MEMORANDUM

To: Development Review Board
From: Mary O'Neil, Associate Planner
Date: July 5, 2011
RE: ZP 11-0086 CA/MA, 323-325 College Street

File: 11-0086 CA/MA

Request: Amendment to original approval issued November 3, 2010; specifically site plan revisions, new access road, revised parking layout and substantially upgraded stormwater retention infrastructure.

PROPOSED
CONDITIONS
SITE PLAN

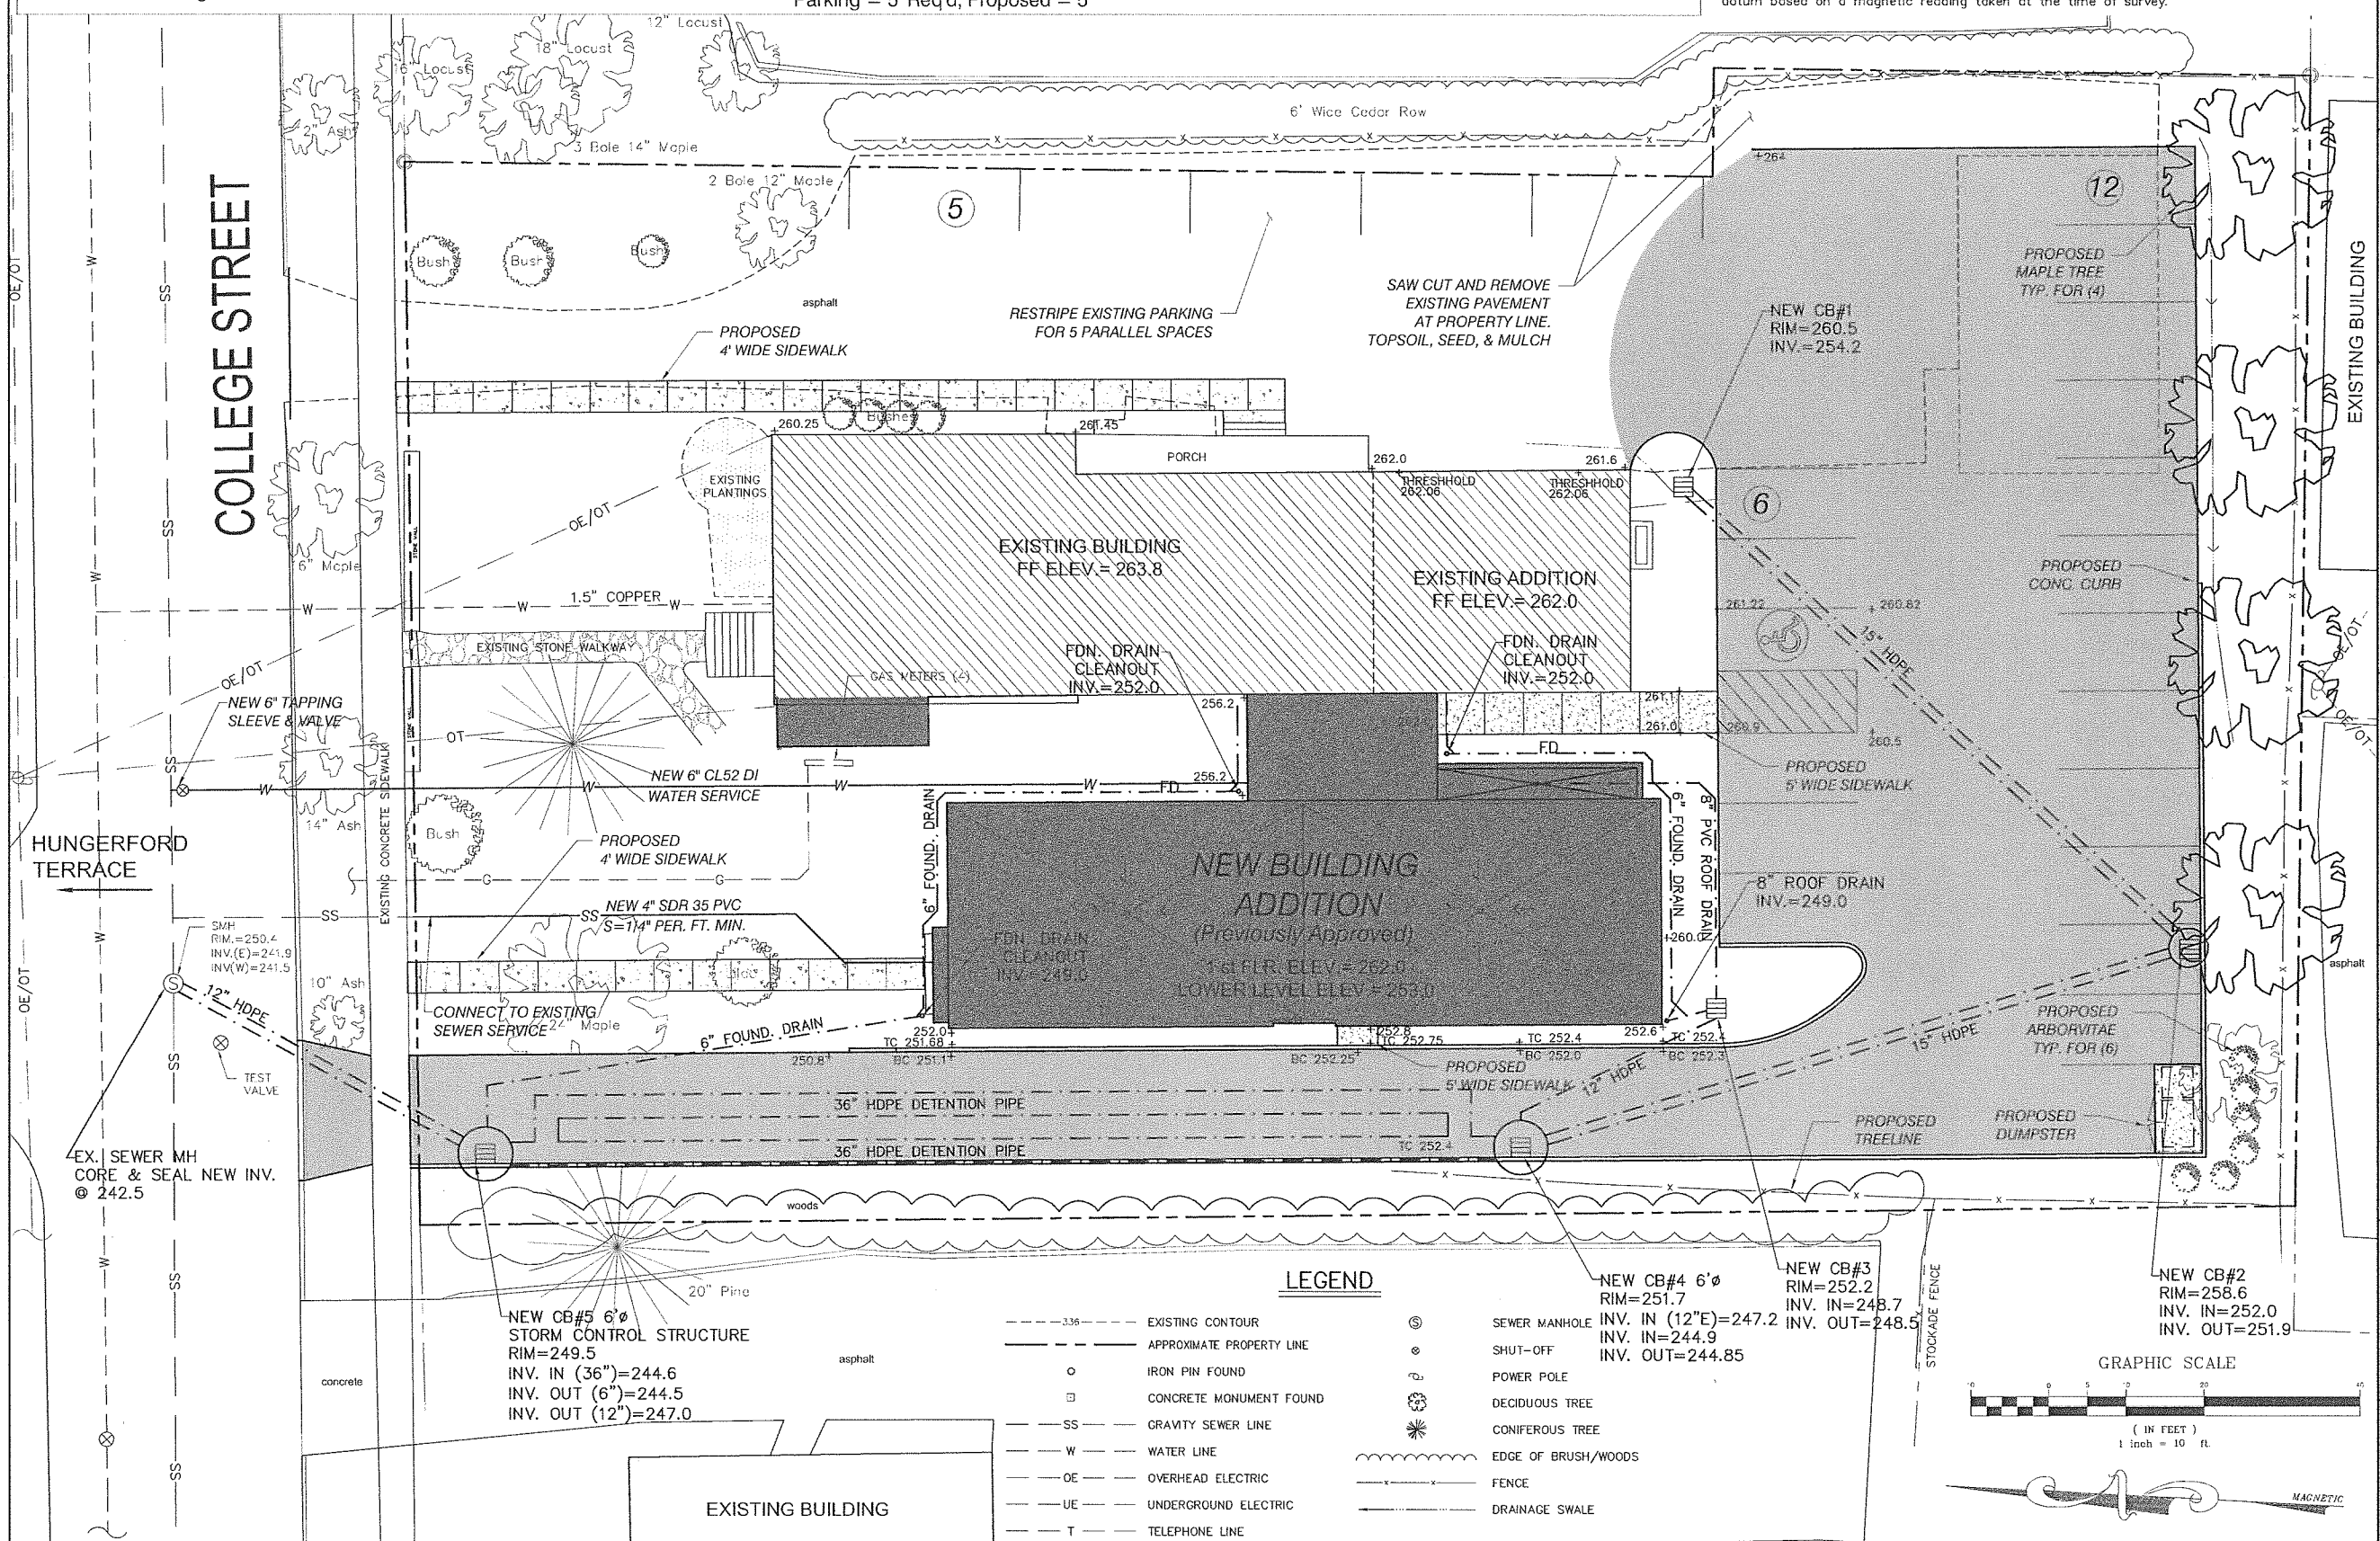
The previously approved parking area had 5 parallel parking spaces on the east boundary and 13 other parking spaces in the rear (one h/c.) This amended application requests 23 parking spaces for the 9 residential units, which meets the 125% maximum allowable per Section 8 of the ordinance (see below.)

Trees per the above specifications have been illustrated on the revised site plan, to shade an estimated 43% of the parking per this standard.

has been approved for removal. The approved retaining wall for the easterly property line has been removed in the amended application; a retaining wall for the re-configured central walkway has been altered. A third retaining wall included in this amendment at the westerly side of the property has been withdrawn from consideration by the applicant.

Multi-unit attached dwelling units require 2 per dwelling unit. For 9 units, 18 parking spaces are required. 23 are illustrated on the amended site plan.

$1.25 \times 18 = 22.5$, or 23 spaces. 23 spaces are illustrated on the amended site plan. **Affirmative finding.**

8. All parking spaces must meet minimum dimensional standards as defined by Table 8.1.11-1 of the CDO. Parallel parking spaces must meet 9' x 22' dimensional standard; parking spaces measuring 8' x 20' must be noted for compact cars only. Compact car spaces, if included, are limited to 15% of the total required parking.

STORM CONTROL STRUCTURE
N.T.S.

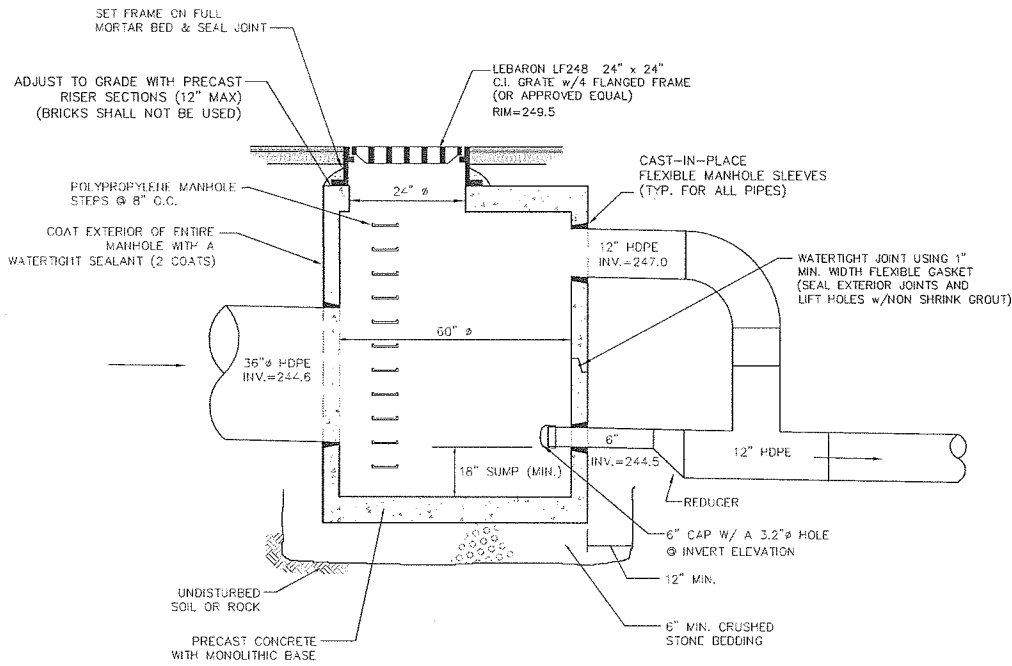
This amendment is a response to the applicant's desire to strengthen the stormwater treatment and retention portion of the project. Two 35" underground pipes have been added to the network of catch basins to more effectively handle the substantial amount of water that comes onto this property.
